SLR Project No.: 141.051021.00001

**RE: Comment Response Letter  
Hingham Center for Active Living, Bare Cove Park Drive, Site Plan Review  
Hingham, Massachusetts**

SLR International Corporation (SLR) is in receipt of correspondence dated January 9, 2026, with comments from Patrick G. Brennan, PE of PGB Engineering, LLC regarding the review of the above-referenced project. We offer the following responses to the comments contained herein.

**TEST PIT SUMMARY PLAN**  
HINGHAM CENTER FOR ACTIVE LIVING  
BARE COVE PARK DRIVE  
HINGHAM, MA

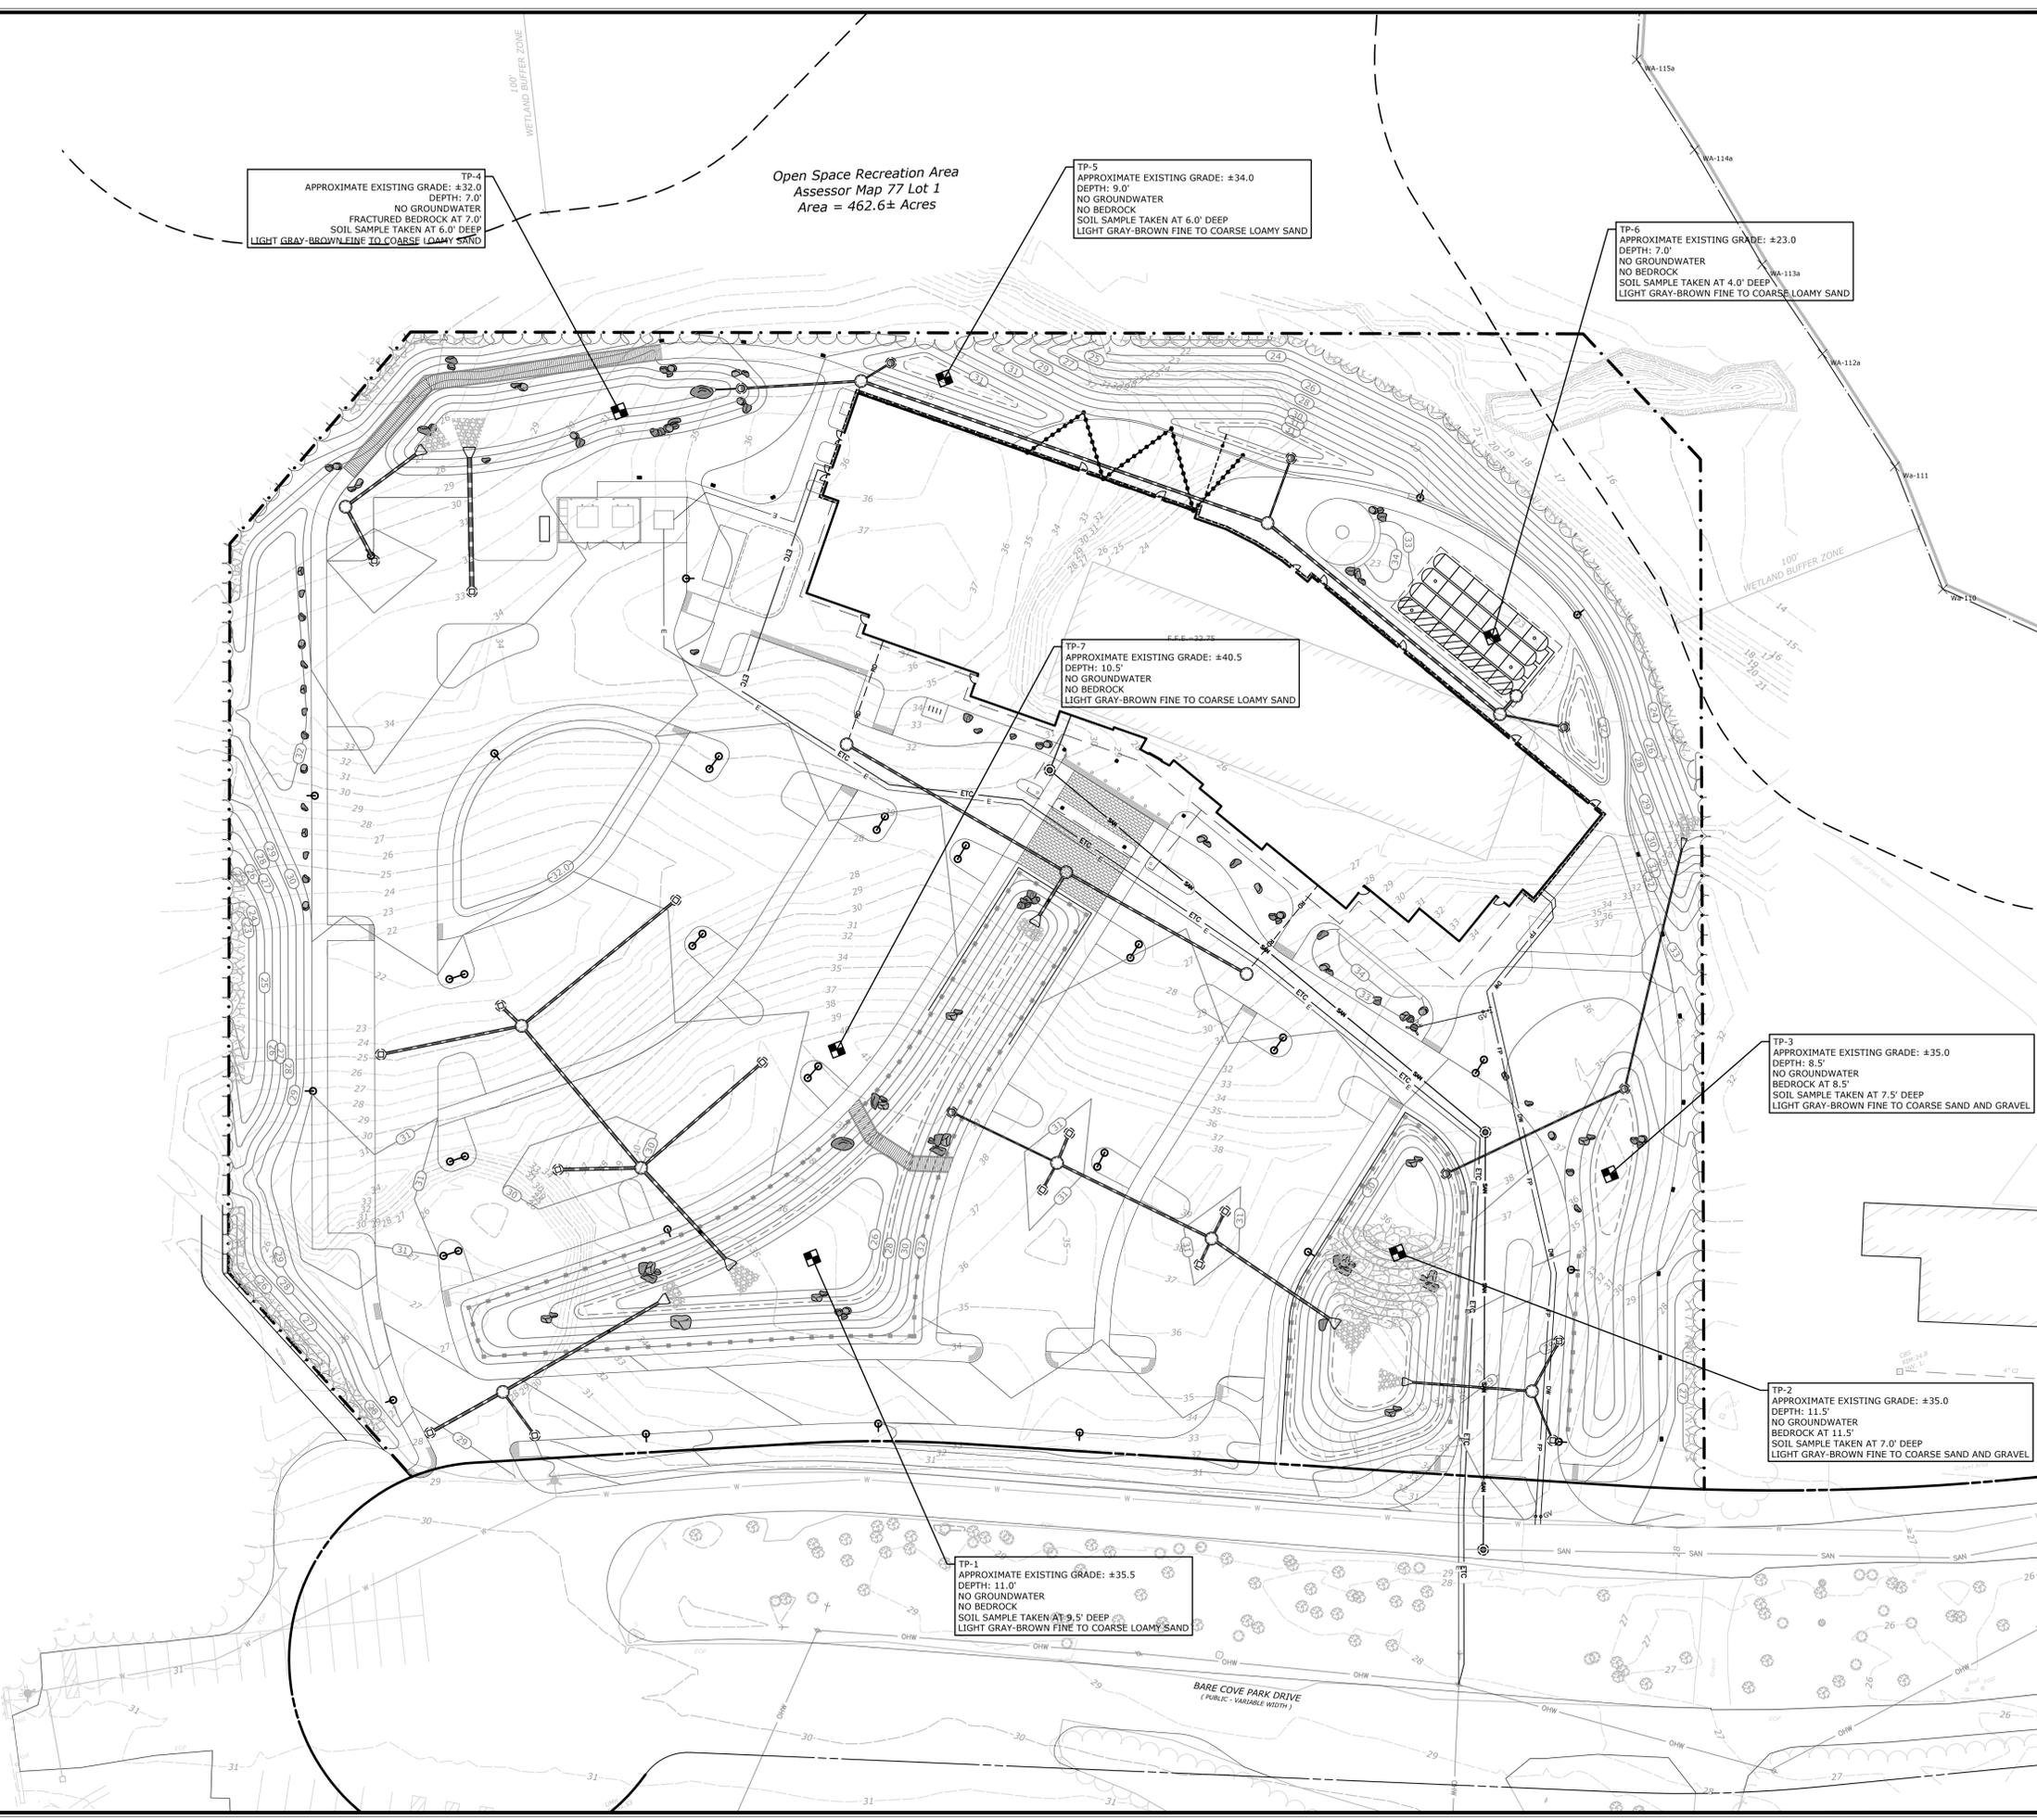
- R1. An updated Stormwater Management Plan has been provided, including the watershed maps.**
- C2. As noted in the Stormwater Management Plan, test holes are required at each of the proposed infiltration facilities to confirm soil textural analysis and depth to seasonal high groundwater. We note that the borings in proximity of the proposed rain garden and infiltration basin IB-2 indicate bedrock at depths close to the bottom elevations of these facilities. Test holes would verify the feasibility of these facilities.

- R2. Test pits were conducted on January 23, 2026, and witnessed by SLR. No groundwater was witnessed and depths to bedrock have been confirmed. See attached Test Pit Summary Plan, which is also included in the updated Stormwater Management Plan. Falling head permeability tests have been performed on soil samples taken during the test pits, and the rates have been applied to the HydroCAD models. The stormwater basins and underground system have been revised to accommodate appropriate separation distances from confirmed bedrock.**
